Docket Number:	16-AAER-02
Project Title:	Appliance Efficiency Rulemaking for Computers, Computer Monitors, and Signage Displays
TN #:	214159
Document Title:	California Investor Owned Utilities Comments: California Investor Owned Utilities: CA IOU Response Computers
Description:	N/A
Filer:	System
Organization:	California Investor Owned Utilities
Submitter Role:	Public
Submission Date:	10/24/2016 3:17:32 PM
Docketed Date:	10/24/2016

Codes and Standards Enhancement (CASE) Initiative
For PY 2016: Title 20 Standards Development

Response to CEC 45-day Express Terms for
Computers

October 24, 2016

Figure 1: Desktop dGPU Dataset, Adders and FBB Exemption Thresholds

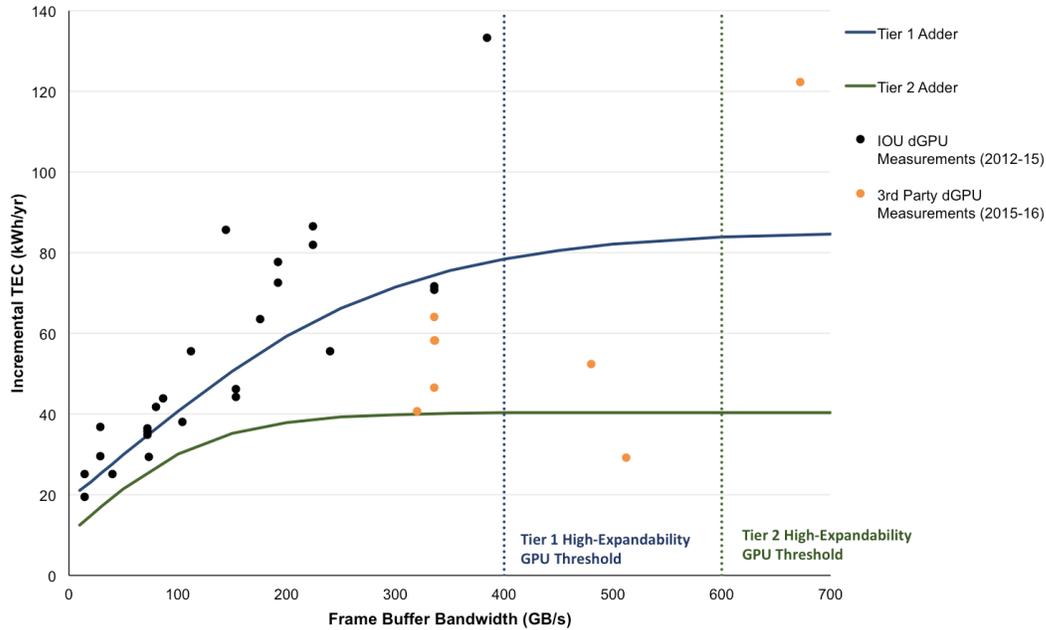
Second, and also as important, the current definition of "High expandability computer" establishes discrete GPU thresholds of 400GB/s and 600GB/s by 2019 and 2020, respectively, as criteria for system exemption, but based on the available data and the industry reported trends, the GPU thresholds should be revised upward for several reasons. First, recent third-party measurements⁷ indicate that today's highest bandwidth GPUs can already easily be accommodated by CEC's proposed GPU adders. Figure 1 illustrates a series of very recent third-party discrete GPU idle measurements, plotted as incremental TEC in kWh/yr (assuming 75% power supply efficiency and the conventional idle duty cycle of 4,380 hours per year). All but one card, a dual-GPU model, fall well below the Tier 1 adder, and one card could already achieve Tier 2 levels. The latest generation of high-bandwidth discrete GPUs are extremely efficient on a TEC-per-bandwidth basis, with 512 GB/s cards idling at the same power levels as previous generation G1 and G2 cards.

Figure 2: CEC and IOU High Expandability GPU Thresholds and Frame Buffer Bandwidth Forecast

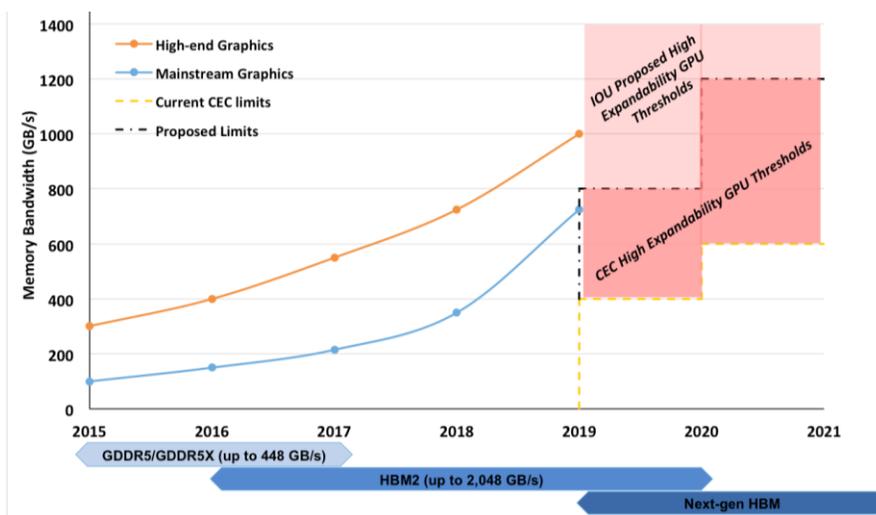
For the reasons above, we recommend that CEC double its current GPU thresholds from 400 to 800 GB/s (until January 2020) and from 600 to 1,200 GB/s (after January 2020). We have illustrated our proposal in Figure 2 with Samsung’s memory market forecast plotted alongside. The proposed thresholds are still expected to exclude the high-end GPU market segment, allowing the latest, highest bandwidth cards to clear the GPU requirements for the high expandability computer exemption.

(2) If the computer is manufactured before January 1, 2020, a power supply of 600 watts or greater and a discrete ~~or integrated~~ graphics with a frame buffer bandwidth of ~~400~~ 800 gigabytes per second (GB/s) or greater; or

(3) If the computer is manufactured on or after January 1, 2020, a power supply of 600 watts or greater and a discrete ~~or integrated~~ graphics with frame buffer bandwidth of ~~600~~ 1,200 gigabytes per second (GB/s) or greater.
